CALIBRATION BLOCKS
FOR
INSERVICE EXAMINATION

INDIAN POINT UNIT NO.3 NUCLEAR POWER PLANT
P.O.BOX 215
BUCHANAN,NEW YORK 10511

NEW YORK POWER AUTHORITY
123 MAIN STREET
WHITE PLAINS,NEW YORK 10601

WESTINGHOUSE ELECTRIC CORPORATION
NUCLEAR SERVICE INTEGRATION DIVISION
INSPECTION SERVICES
P.O.BOX 355
PITTSBURGH,PANNSYLVANIA 15230

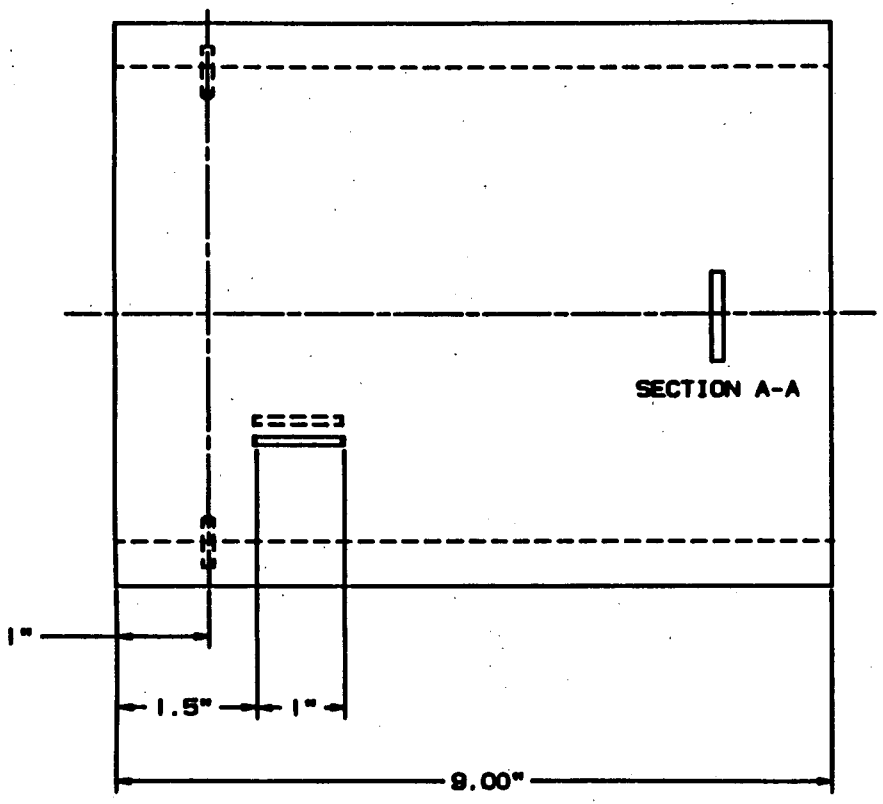
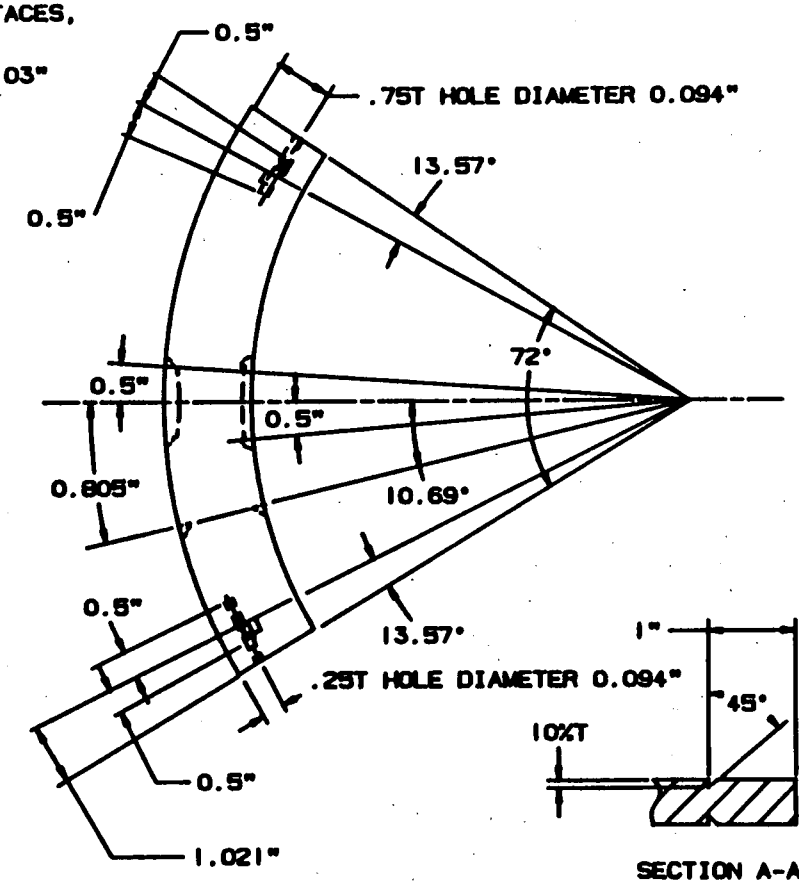
Calibration block design follows the guidelines of Section V and Section XI - 1983 Edition through Summer 1983 Addenda for Austenitic Piping. Use of 8" SCH 160 is nearest piping diameter and thickness available for Regenerative Heat Exchanger Requirements. Modifications of this design to meet the requirements of Section V and Section XI 1983 Edition through Summer 1983 Addenda for "ferritic piping and design T-547.1" would be to increase arc length to 120° and as required by Table III-3430-1 notch depth to 0.104T - 0.009T squared with tolerance of +10%-20%. P-Number Groupings for Materials A312 TP304 Stainless Steel, A376 TP316 Stainless Steel and A213 TP304 Stainless Steel are equivalent.

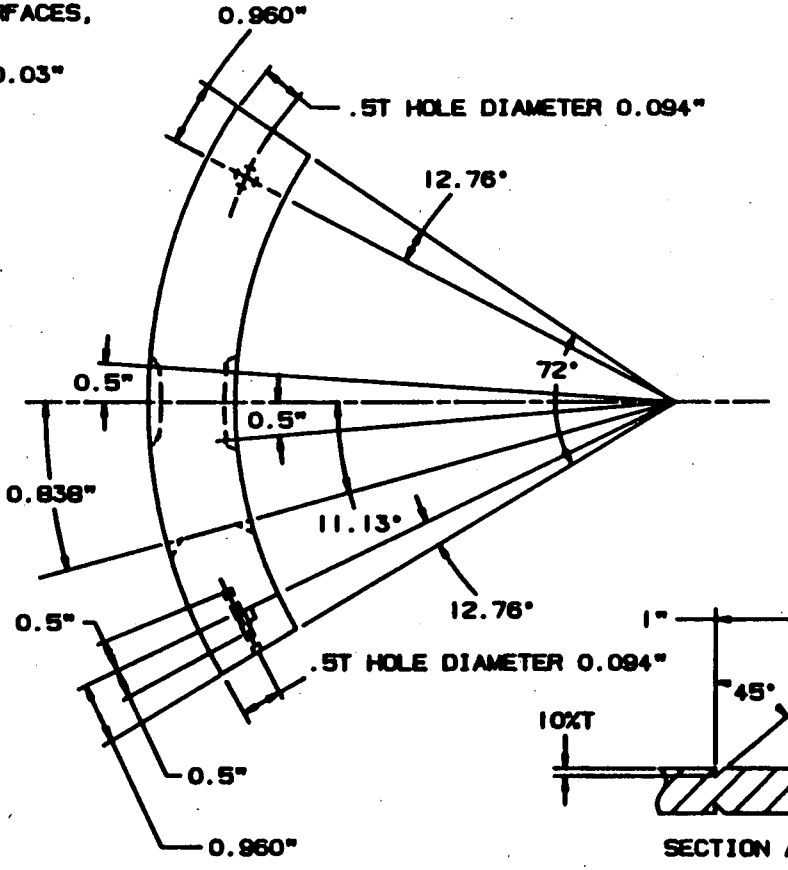
Calibration block design follows the guidelines of Section V and Section XI - 1983 Edition through Summer 1983 Addenda for Austenitic Piping. Use of 8" SCH 120 is nearest piping diameter and thickness available for Excess Letdown Heat Exchanger. Modifications of this design to meet the requirements of Section V and Section XI 1983 Edition through Summer 1983 Addenda for "ferritic piping and design T-547.1" would be to increase arc length to 120° and as required by Table III-3430-1 notch depth to 0.104T - 0.009T squared with tolerance of +10%-20%. P-Number Groupings for Materials A312 TP304 Stainless Steel, A376 TP316 Stainless Steel and SA240 TP316 Stainless Steel are equivalent.

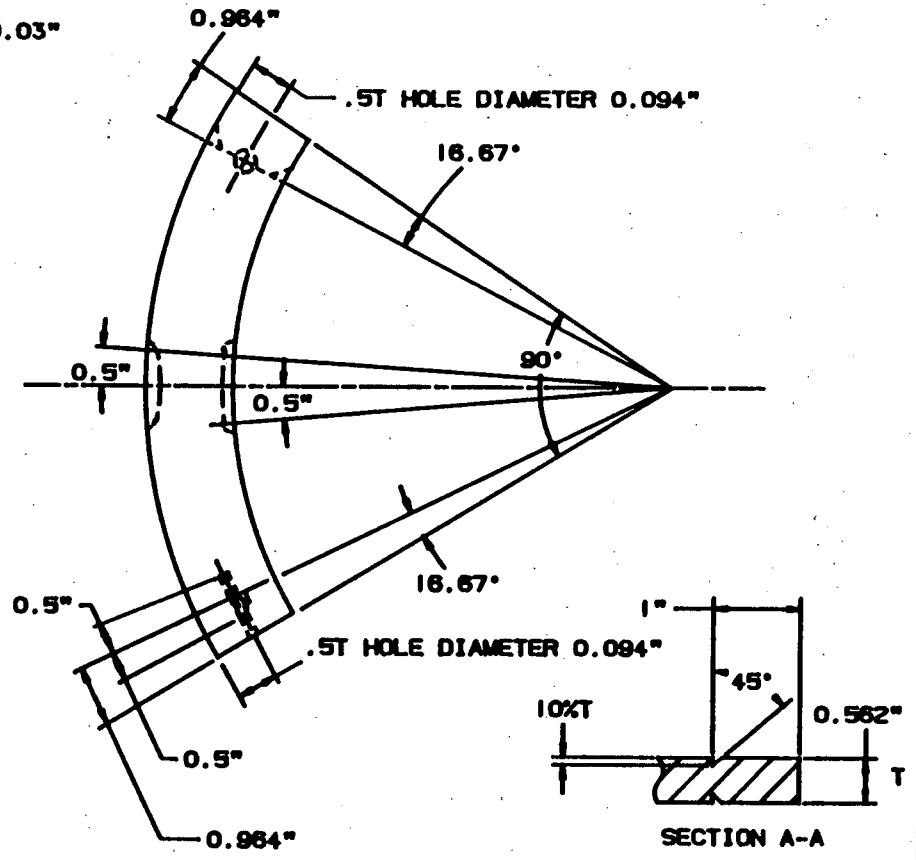
Calibration block design follows the quidelines of Section V and Section XI - 1983 Edition through Summer 1983 Addenda for Austenitic Piping. Modifications of this design to meet the requirements of Section V and Section XI - 1983 Edition through Summer 1983 Addenda for "ferritic piping and design T-547.1" would be to increase arc length to 160° and as required by Table III-3430-1 notch depth to 0.104 - 0.009T squared with tolerance of +10%-20%.

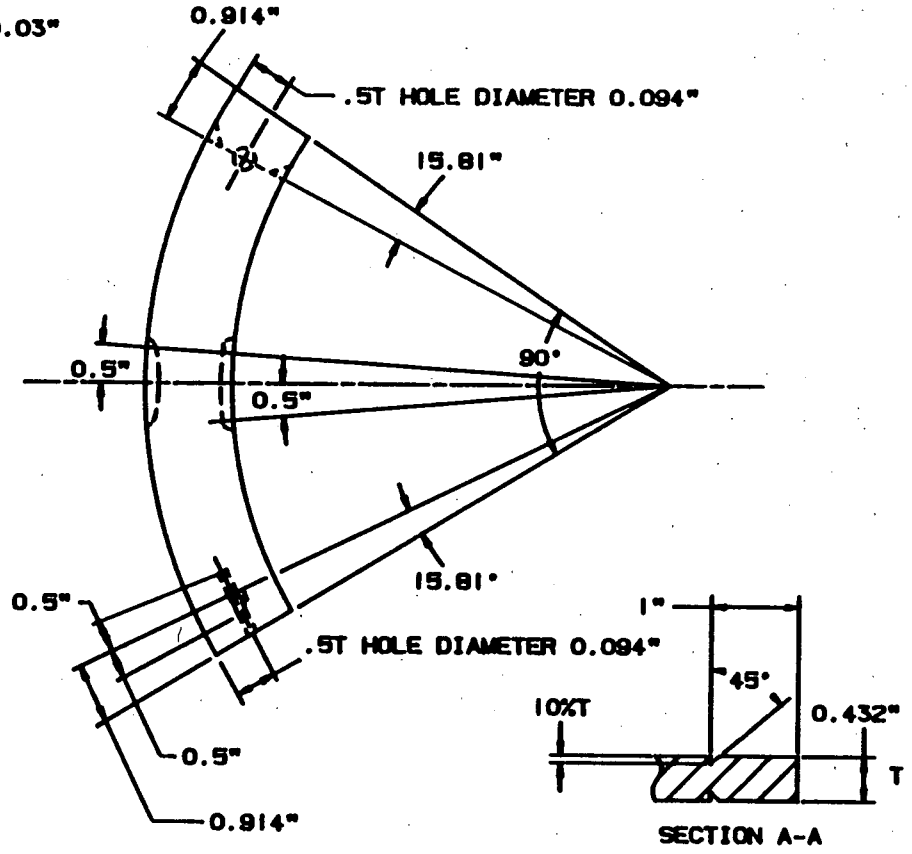
Calibration block design follows the quidelines of Section V and Section XI - 1983 Edition through Summer 1983 Addenda except for arc length of 160° instead of 90° and length of 8" instead of 6" as required by Figure T-547.1 and as required by Table III-3430-1 notch depth to 0.104T - 0.009T squared with tolerance of +10%-20%. Class 2 Piping less than or equal to 1/2 inch thickness no longer requires Volumetric examination per the requirements of Section XI - 1983 Edition through Summer 1983 Addenda.

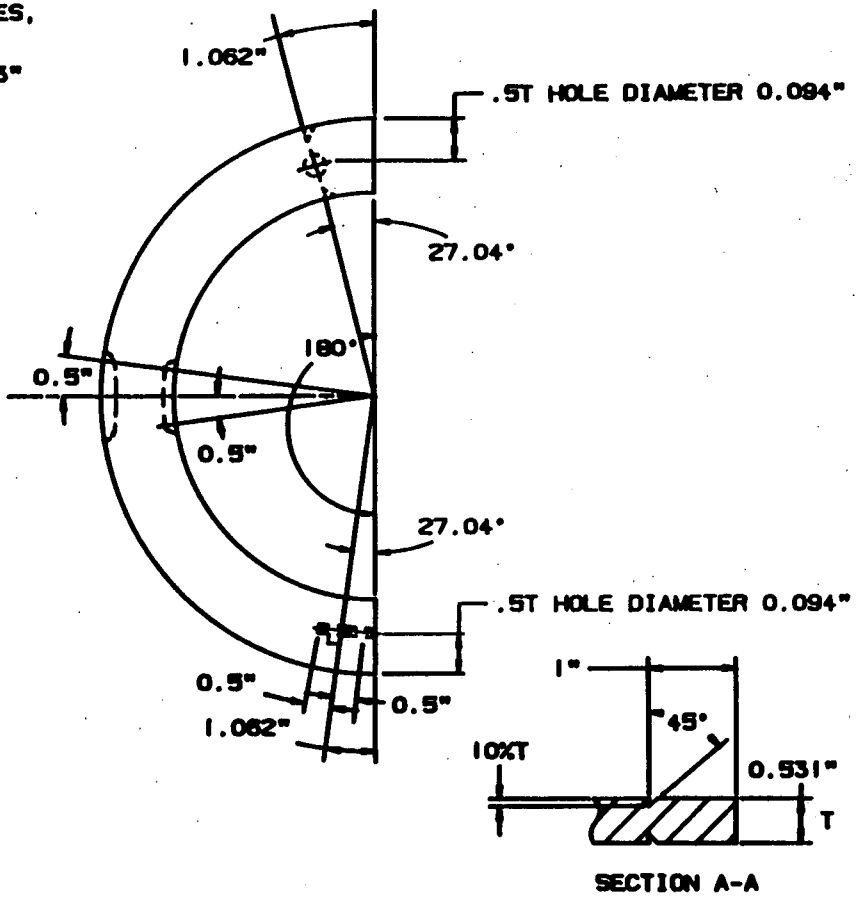
Calibration block design follows the quidelines of Section V and Section XI - 1983 Edition through Summer 1983 Addenda for Austenitic Piping. Modifi- cations of this design to meet the requirements of Section V and Section XI - 1983 Edition through Summer 1983 Addenda for "ferritic piping and design T-547.1" would be to increase length to 8", arc length to 270° and as required by Table III-3430-1 notch depth to 0.104T - 0.009T squared with tolerance of +10-20%. Section XI - 1983 Edition through Summer 1983 Addenda allows for a Volumetric or surface examination of Control Rod Drive Mechanisms which would delete any requirement for a calibration block if surface examination is performed. P-Number Groupings for Materials A376 TP304 Stainless Steel and A376 TP316 Stainless Steel are equivalent.

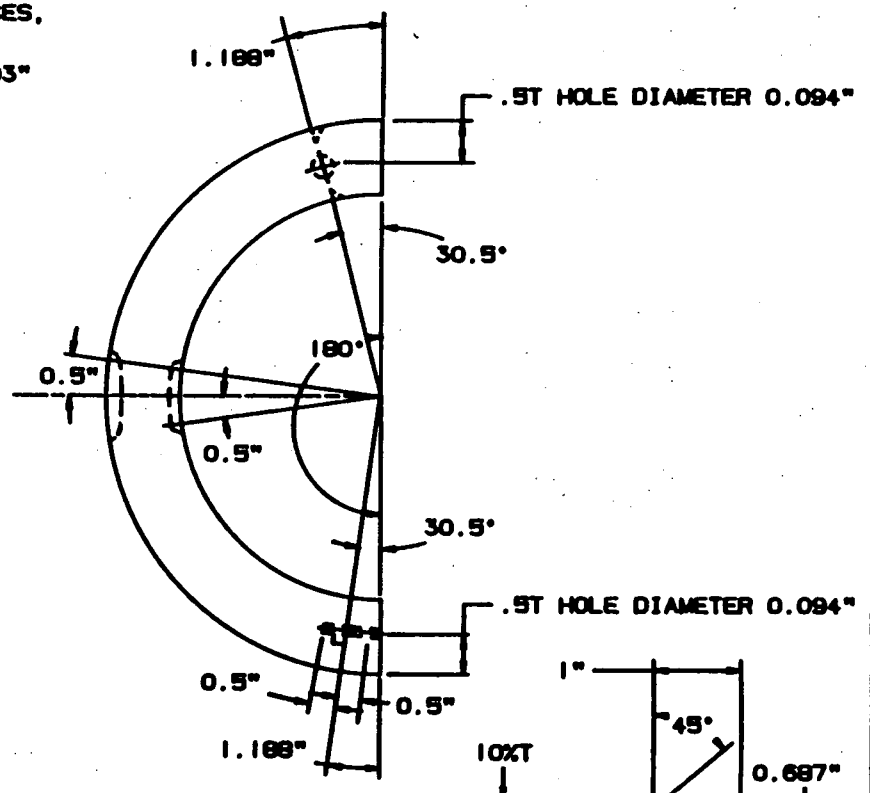
Calibration block design follows the quidelines of Section V and Section XI - 1983 Edition through Summer 1983 Addenda for Austenitic Piping. Modifications of this design to meet the requirements of Section V and Section XI - 1983 Edition through Summer 1983 Addenda for "ferritic piping and design T-547.1" would be to increase arc length 270° and as required by Table III-3430-1 notch depth to 0.104T - 0.009T squared with tolerance of +10-20%. P-Number Groupings for Materials A312 TP304 Stainless Steel and A376 TP316 Stainless Steel are equivalent.

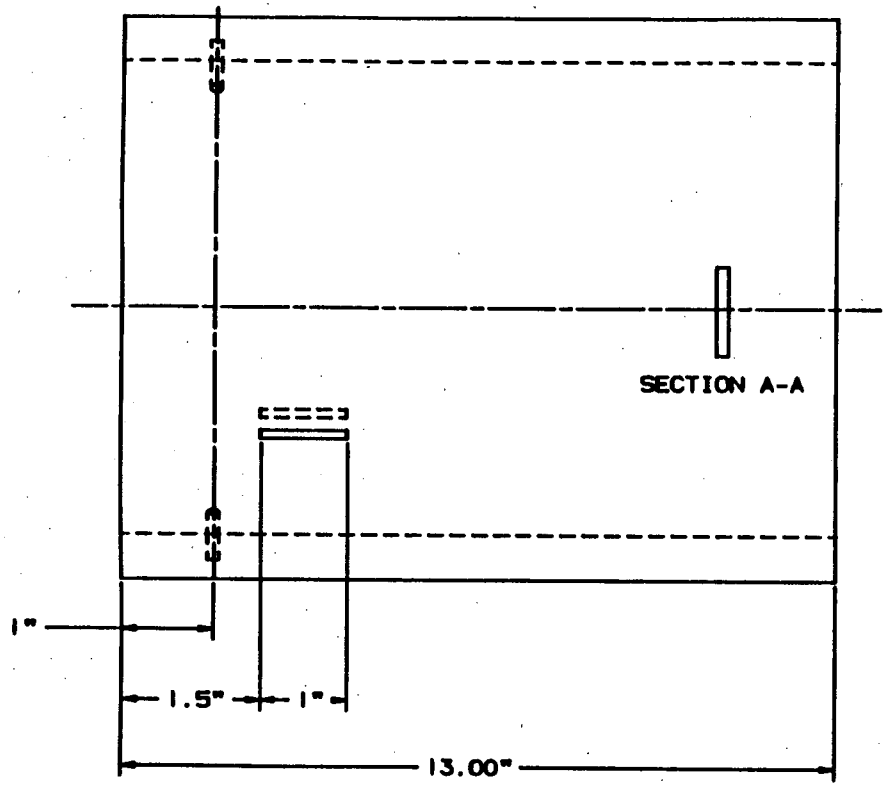
Calibration block follows the design and requirements for Section V and Section XI of the 1983 Edition through Summer 1983 Addenda except for axial notches located only 1" from block edge instead of 1.5" minimum as required by Figure T-547.1 and notch depth to 0.104"T - 0.009T squared with tolerance of +10%-20% as required by Table III-3430-1. P-Number Groupings for Materials A515 Grade 70 Carbon Steel and A234 WPC Carbon Steel are equivalent.

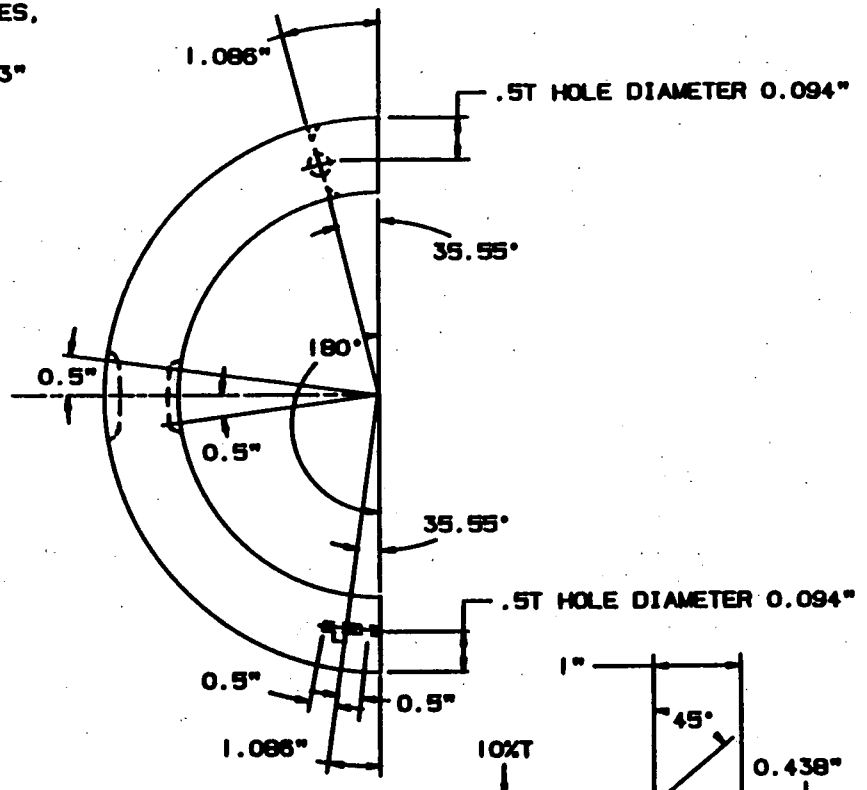
Calibration block design follows the quidelines of Section V and Section XI - 1983 Edition through Summer 1983 Addenda for Austenitic Piping. Class 1 Piping less than 4 inch nominal pipe size no longer requires Volumetric examination per the requirements of Section XI - 1983 Edition through Summer 1983 Addenda. Modifications of this design to meet the requirements of Section V and Section XI - 1983 Edition through Summer 1983 Addenda for calibration blocks for "ferritic piping and design T-547.1" would be to increase arc length to 270° and length to 8" and as required by Table III-3430-1 notch depth to 0.104T - 0.009T squared with tolerance of +10%-20%.

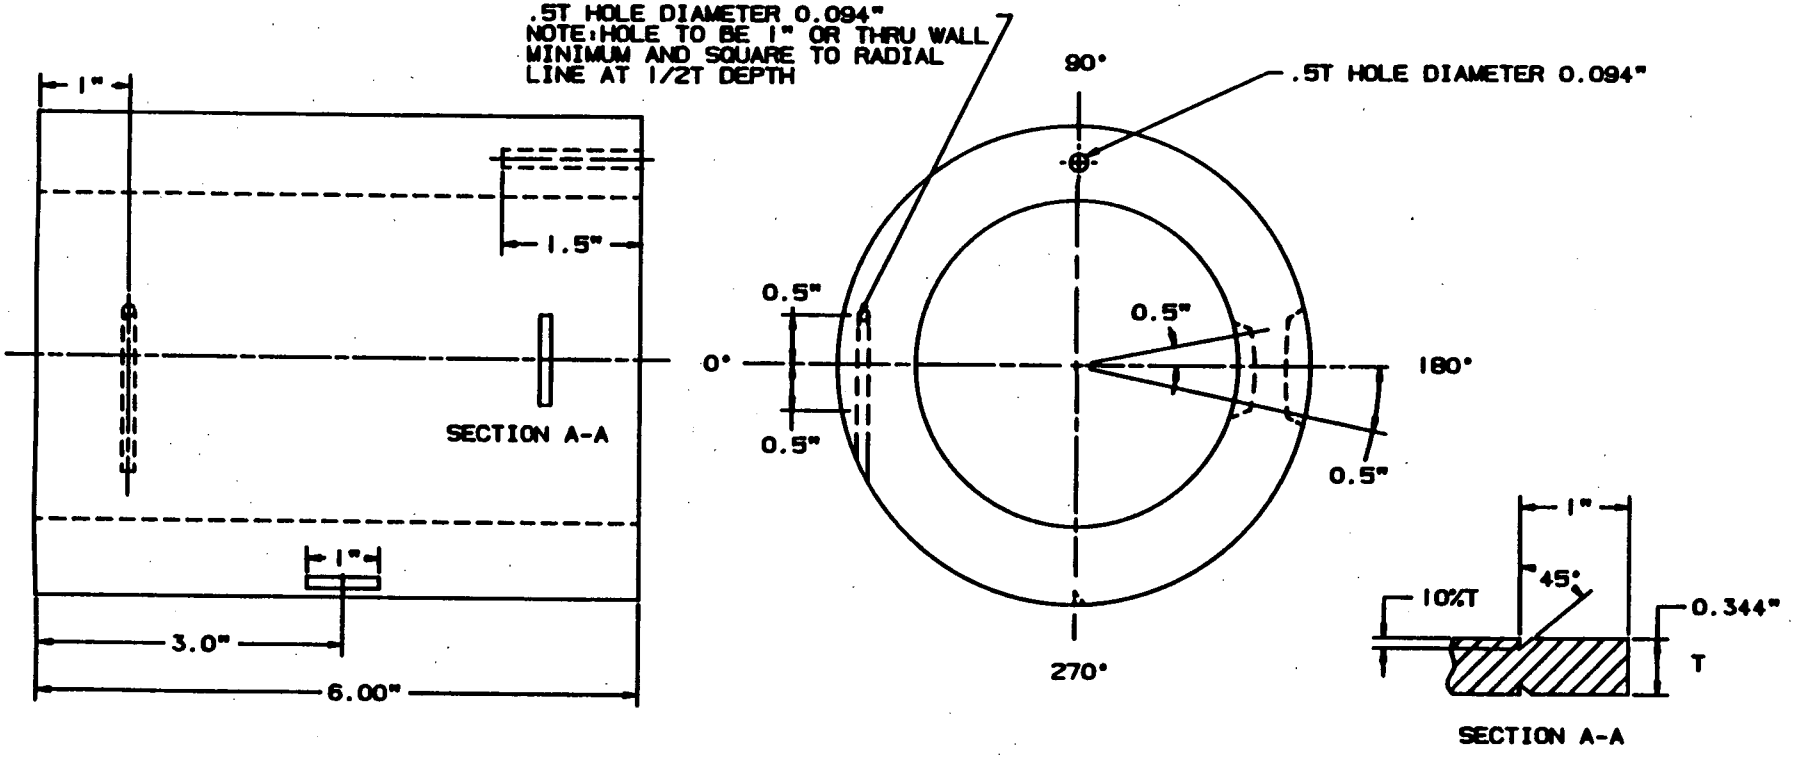
Calibration block design follows the quidelines of Section V and Section XI - 1983 Edition through Summer 1983 Addenda for Austenitic Piping. Class 1 Piping less than 4 inch nominal pipe size no longer requires Volumetric examination per the requirements of Section XI - 1983 Edition through Summer 1983 Addenda. Modifications of this design to meet the requirements of Section V and Section XI - 1983 Edition through Summer 1983 Addenda for calibration blocks for "ferritic piping and design T-547.1" would be to increase length to 8" and add I. D. circumferential notch and as required by Table III-3430-1 notch depth to 0.104T - 0.009T squared with tolerance of +10%-20%.

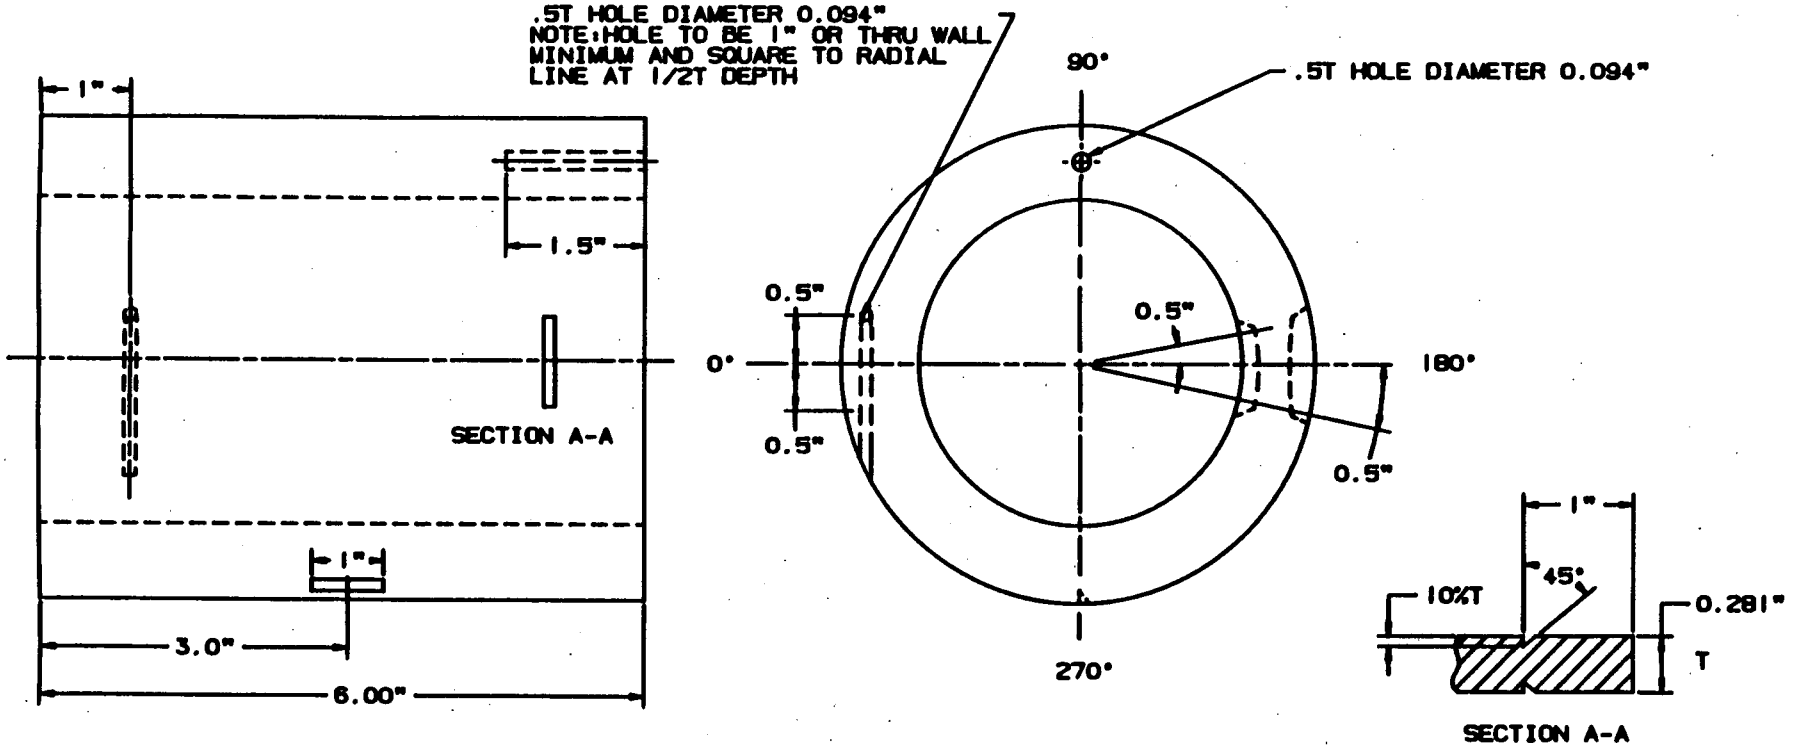
Calibration block design follows the quidelines of Section V and Section XI - 1983 Edition through Summer 1983 Addenda for Austenitic Piping. Class 1 Piping less than 4 inch nominal pipe size no longer requires Volumetric examination per the requirements of Section XI - 1983 Edition through Summer 1983 Addenda. Modifications of this design to meet the requirements of Section V and Section XI - 1983 Edition through Summer 1983 Addenda for calibration blocks for "ferritic piping and design T-547.1" would be to increase length to 8" and add I. D. circumferential notch. P-Number Groupings for Materials A376 TP316 Stainless Steel and A312 TP316 Stainless Steel are equivalent.
